Sweater Evaluation Images: Issues and Solutions

GLOBAL TECHNICAL DESIGN

Sweater Evaluation Images

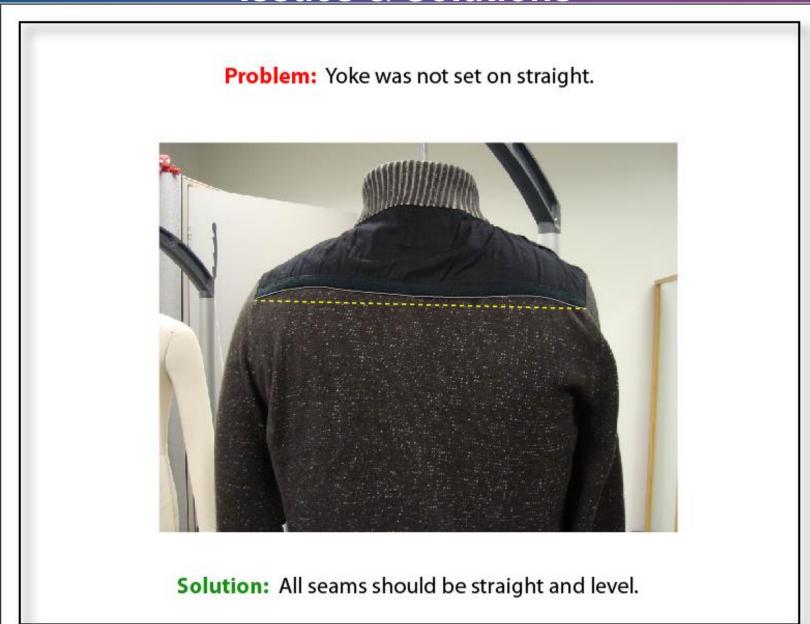
Incorrect:

Zipper length is too long, and zipper is not laying nicely on the body.

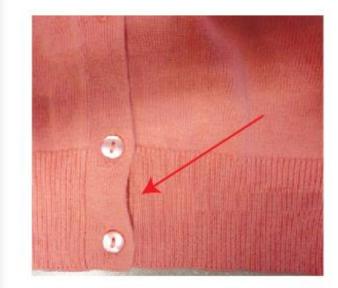
Correct:

Zipper length is correct and zipper is laying flat to the body.

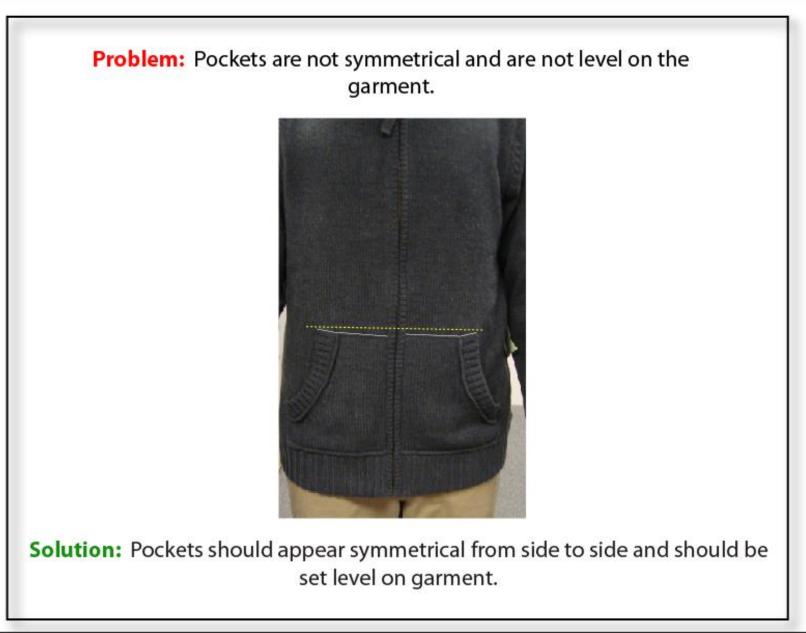
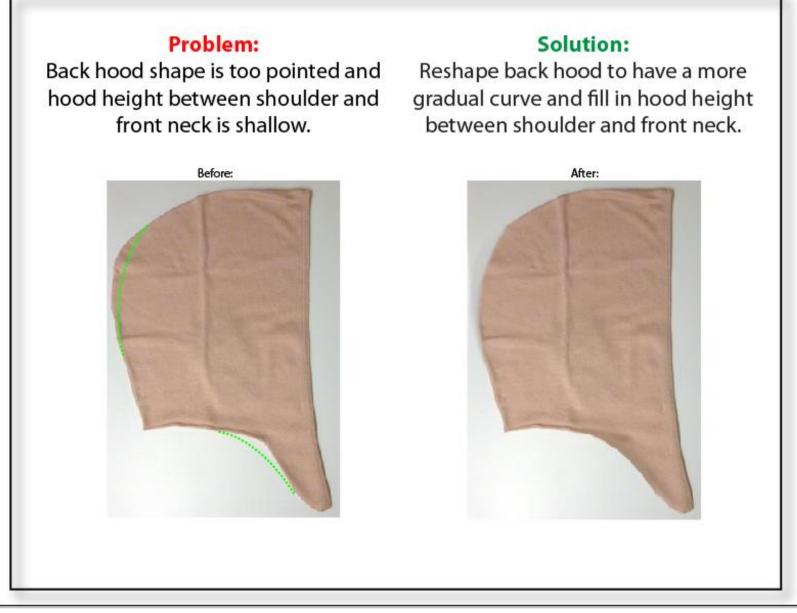
Incorrect: Placket is too short and is pulling up at CF, causing drag lines.

Correct: Placket hangs evenly at hem and there are no drag lines.

Correct: Placket is not stretched out and lays nicely closed when worn, press garment unbuttoned if needed.

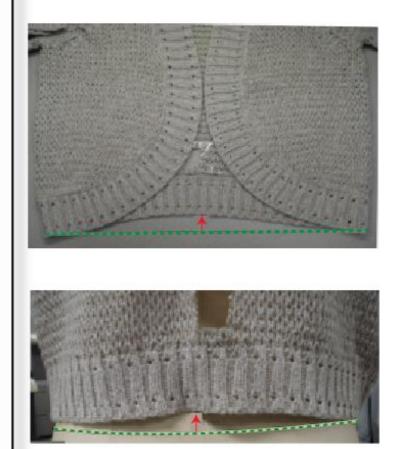
Problem:

Garment is curving up at back hem both flat and on the body.

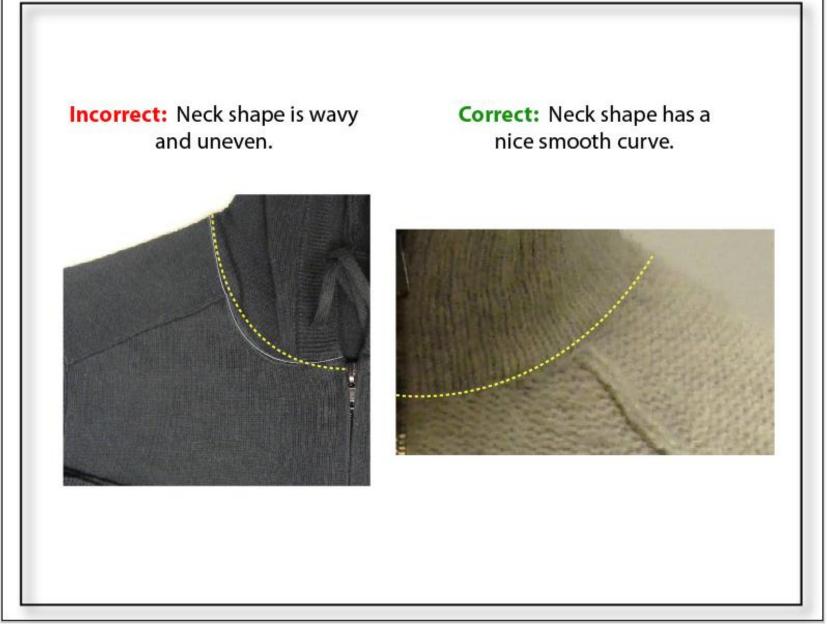
Solution:

Add length to the back panel at neck and shoulder as needed to allow sweep to be level.
